**FCPS NEW MIDDLE SCHOOL – POLO CLUB**  
**KDE BG # 21-176**  
**FCPS BID # 20-21**  
**JRA Project No. 202078**  
Fayette County Public Schools  
Lexington, Kentucky

The Addendum will form a part of the Contract Documents and modifies the original Bidding Documents dated September 2021.

**FP-111F**

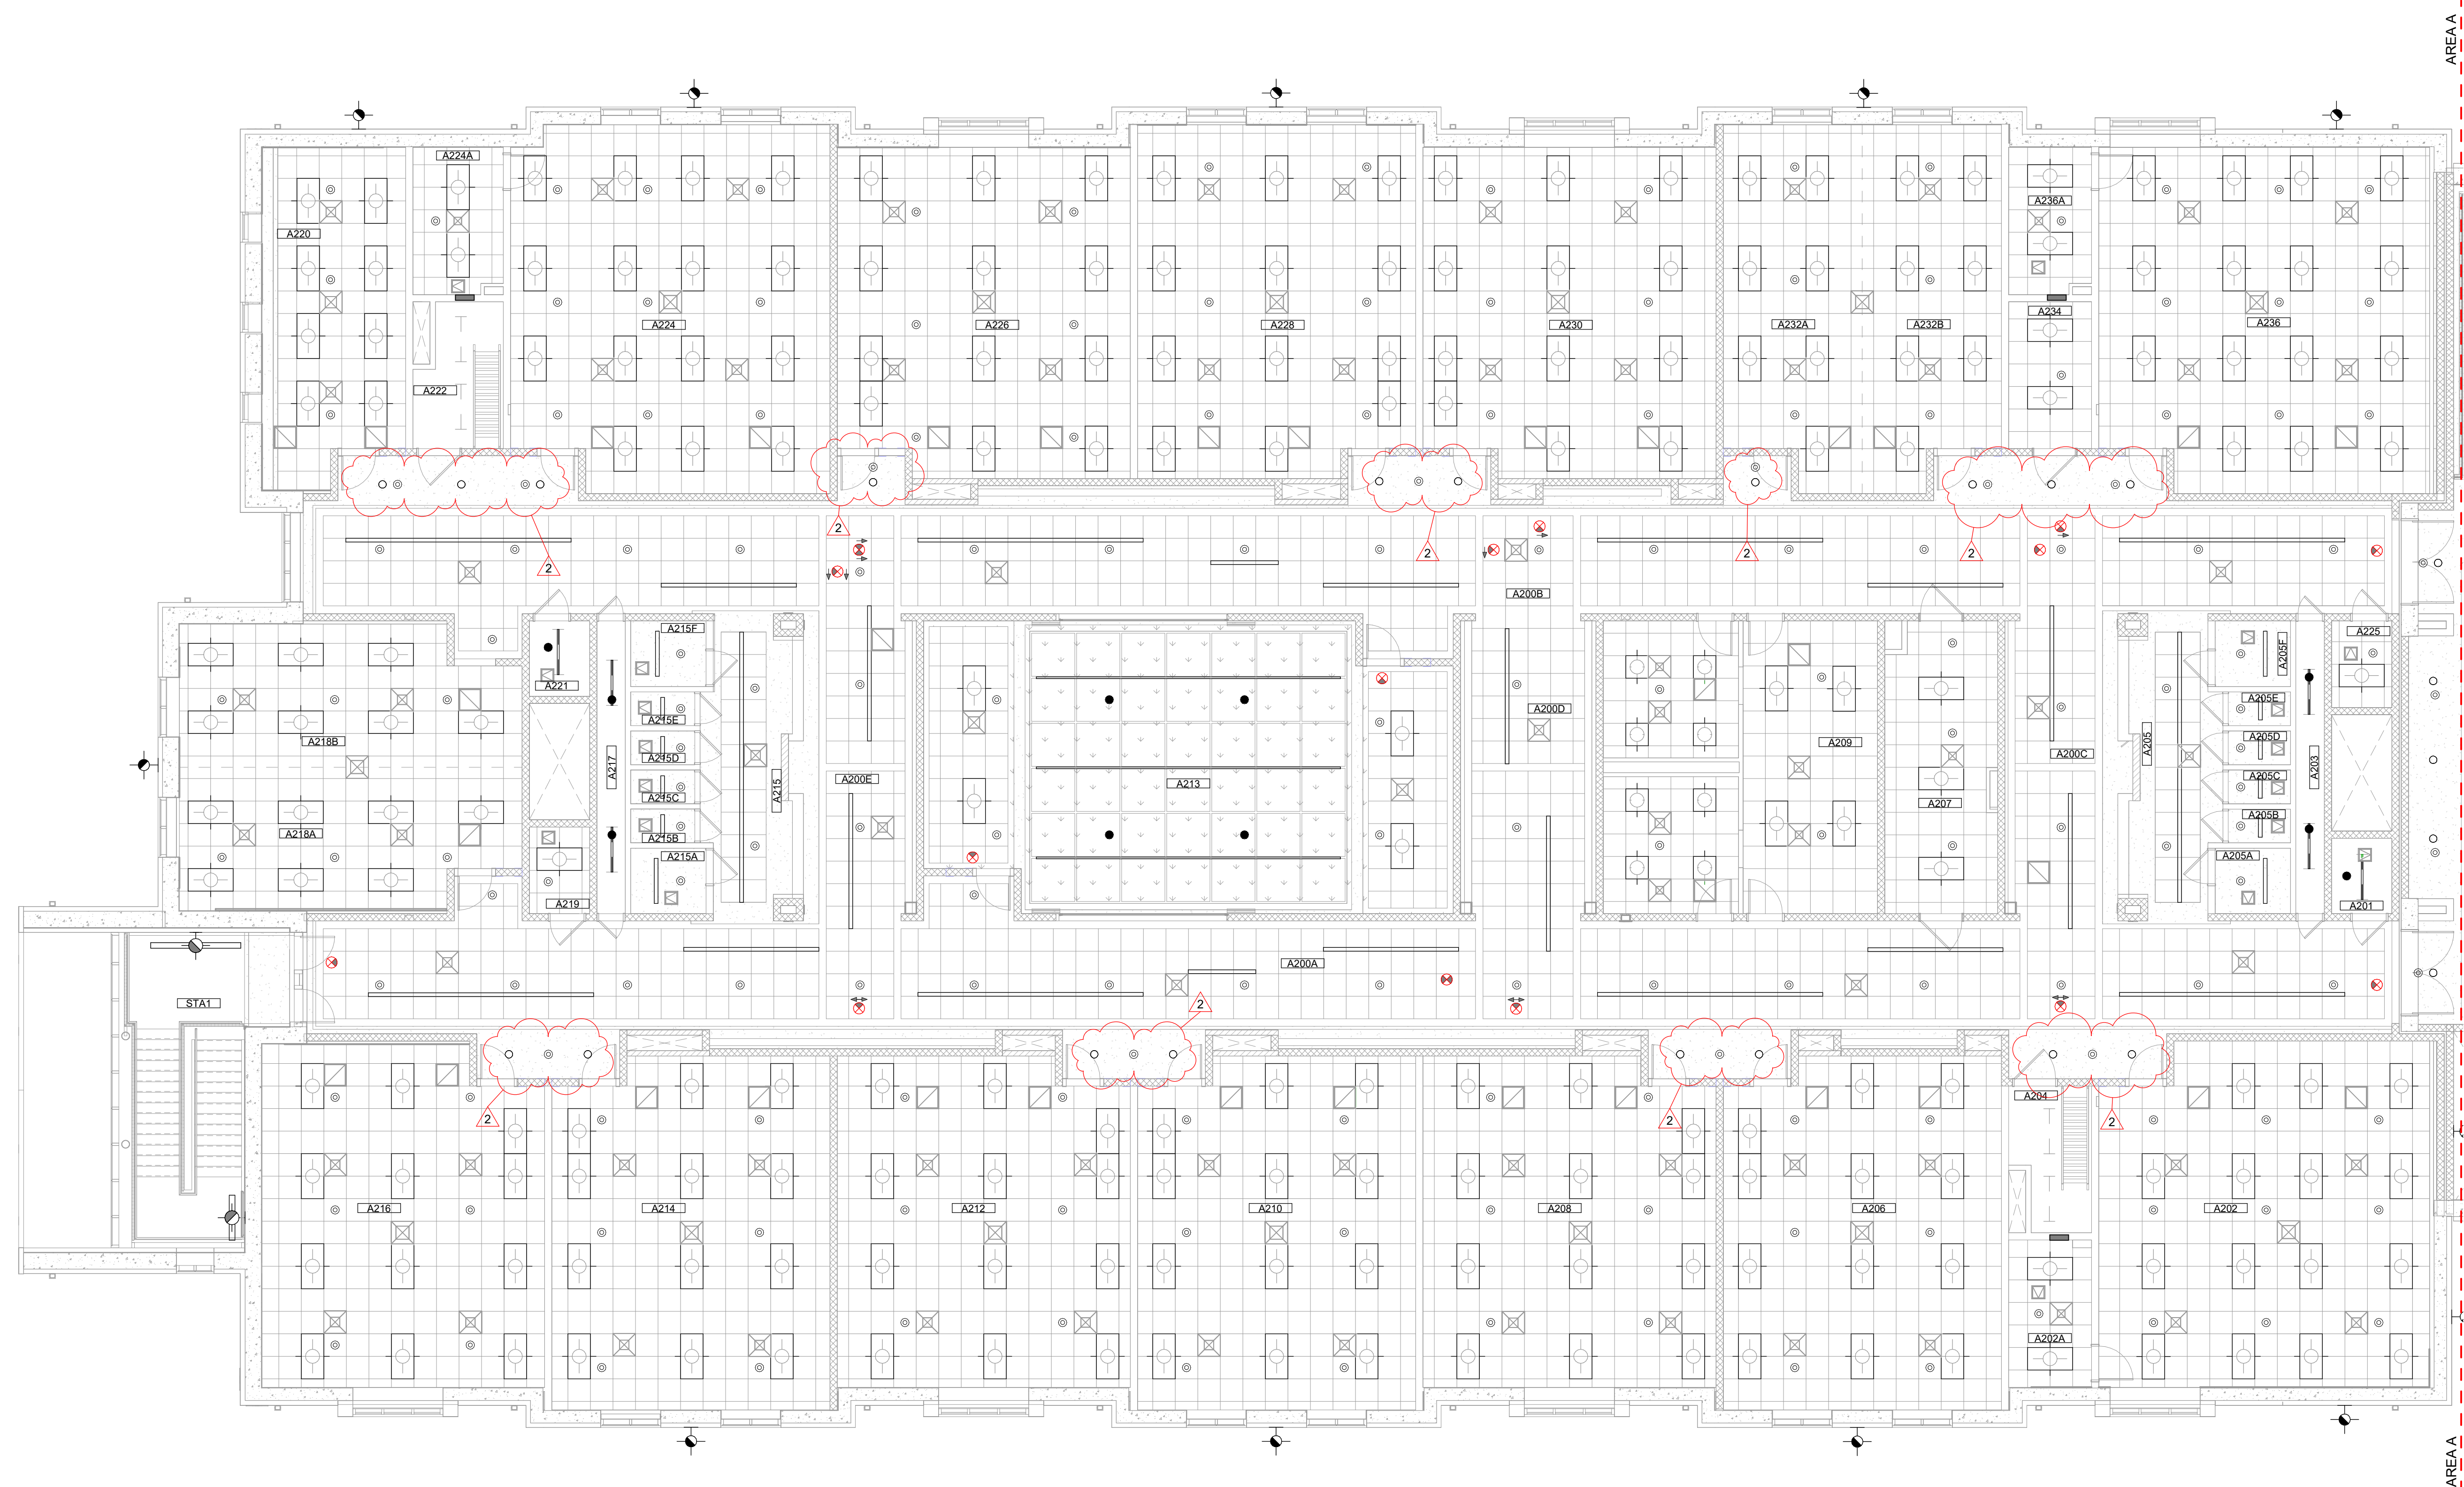
Refer to sheet FP-111F adjust Sprinkler Head locations as indicated.

**SECOND FLOOR FIRE PROTECTION PLAN - AREA A**  
**FP-112A**  
COPYRIGHT 2021 - JRA, INC.

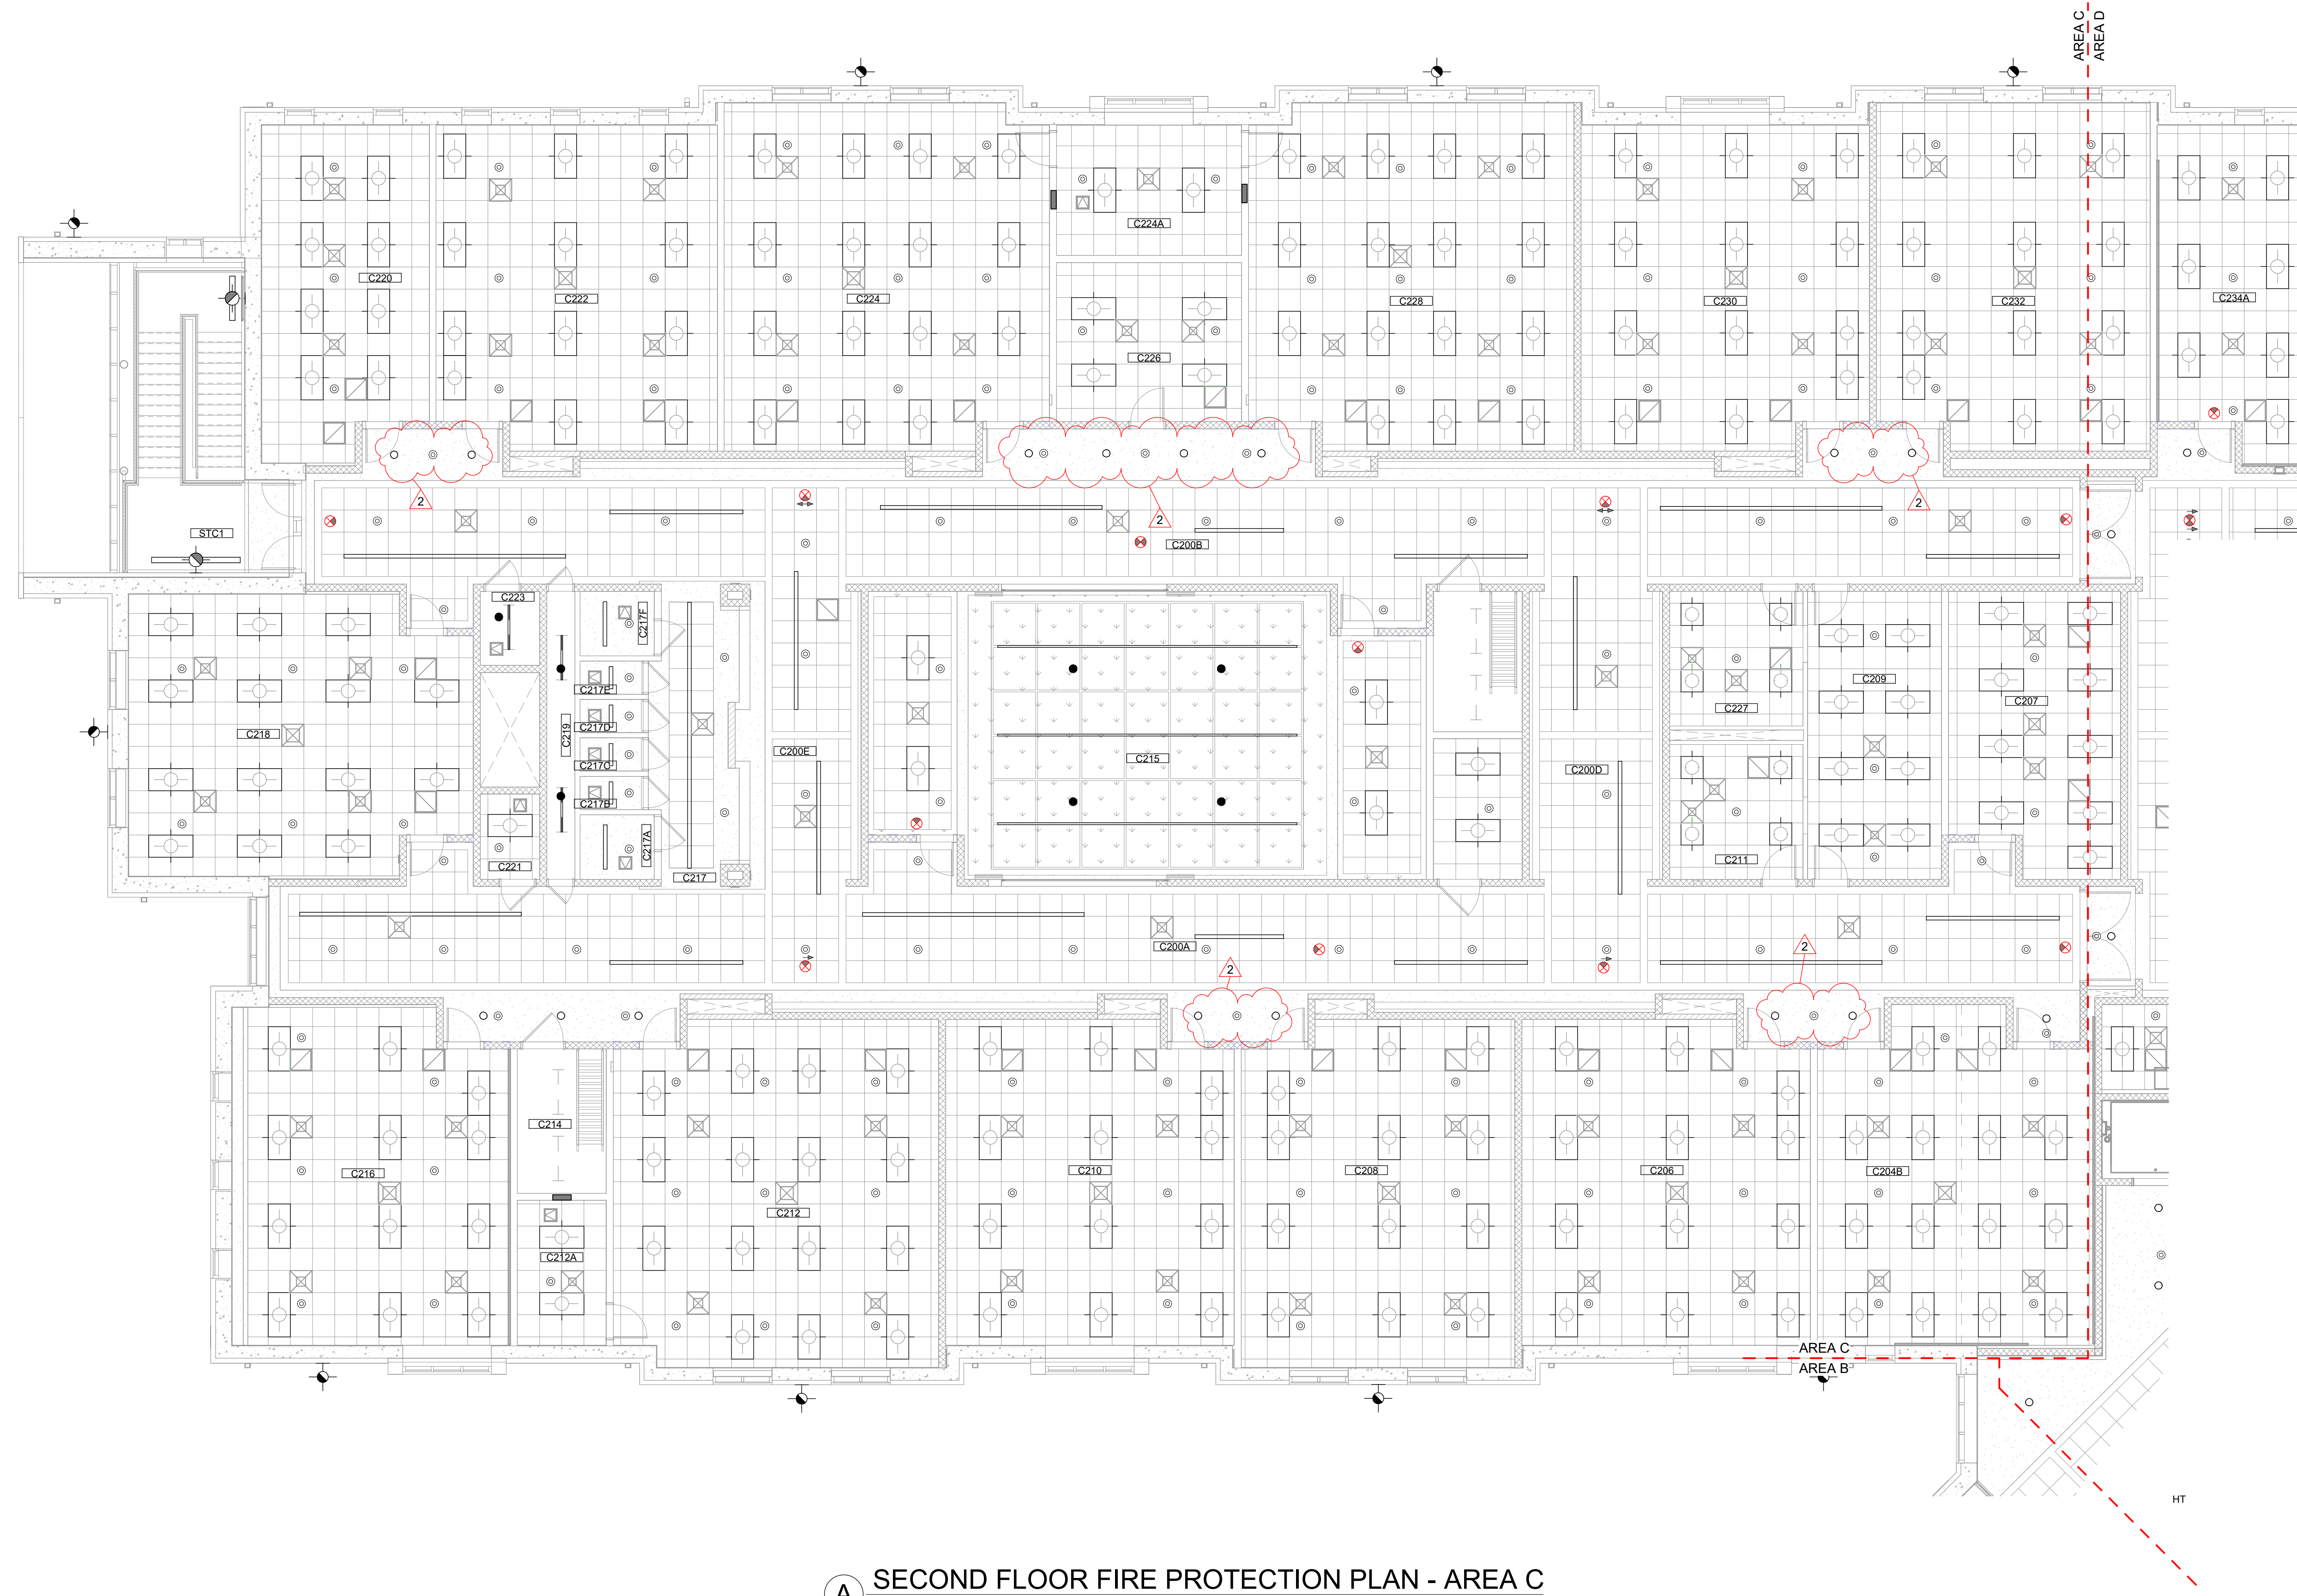
Refer to sheet FP-112A adjust Sprinkler Head locations as indicated.

**FP-112C**

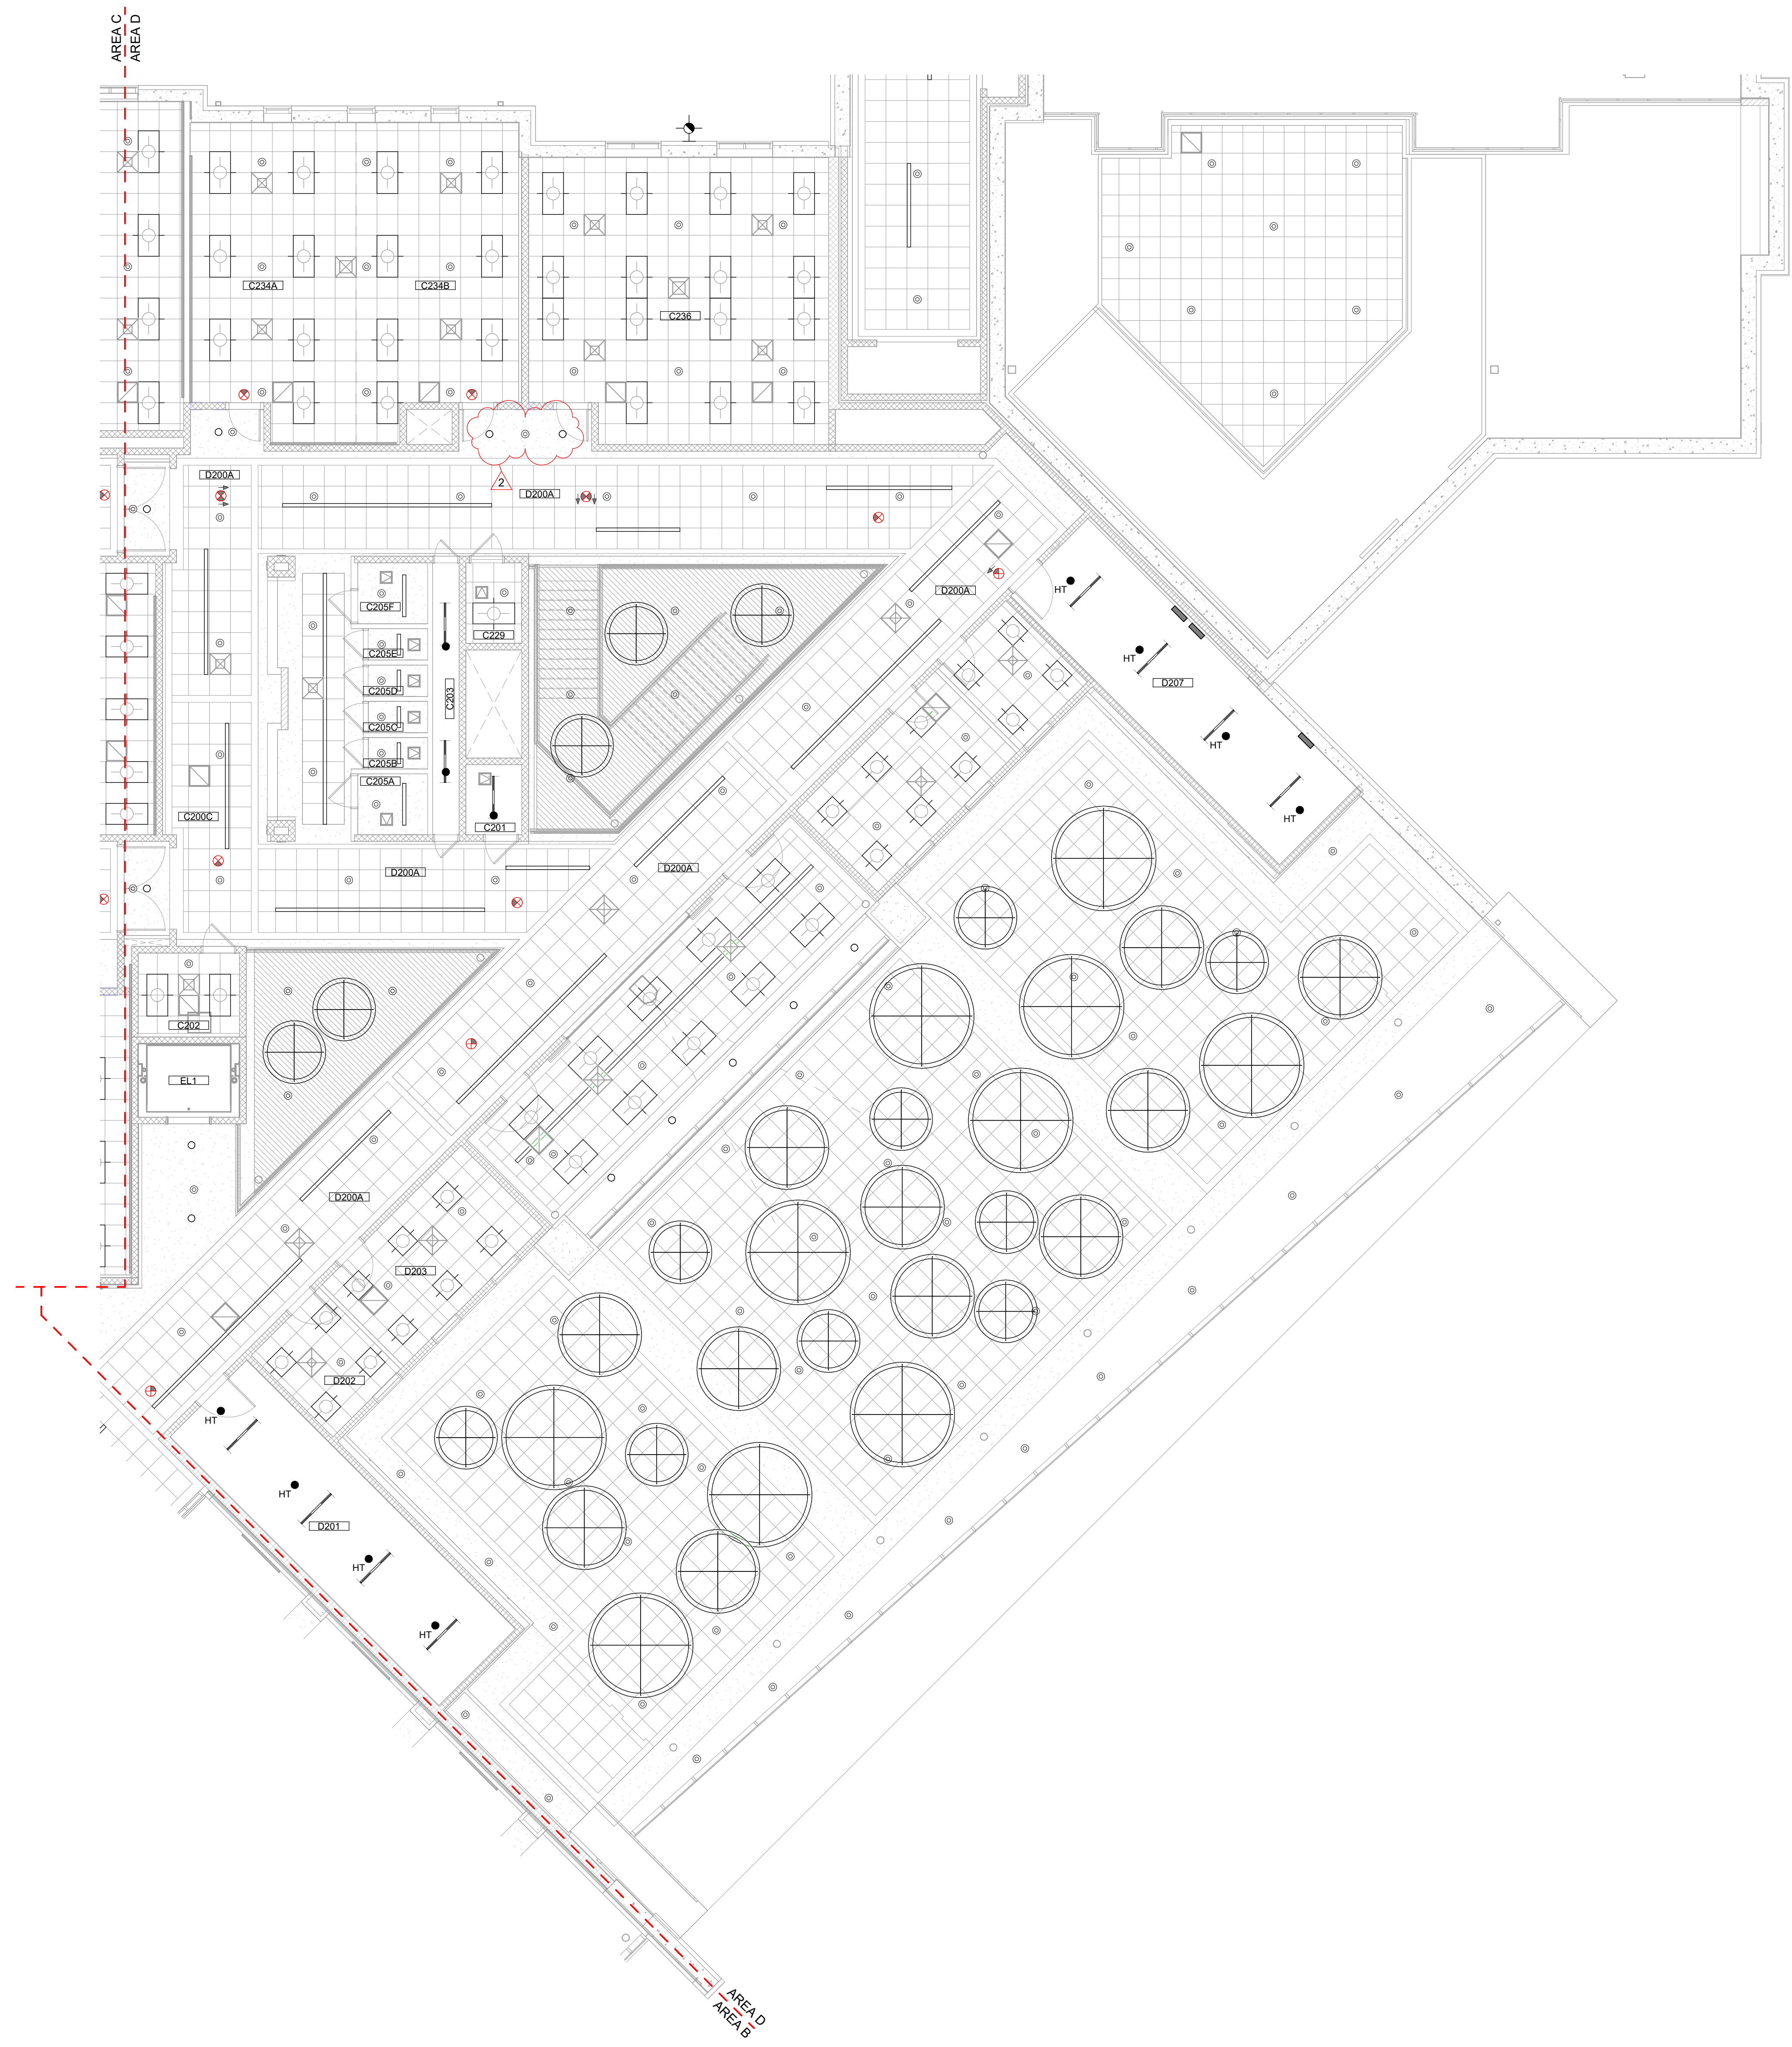
Refer to sheet FP-112C adjust Sprinkler Head locations as indicated.
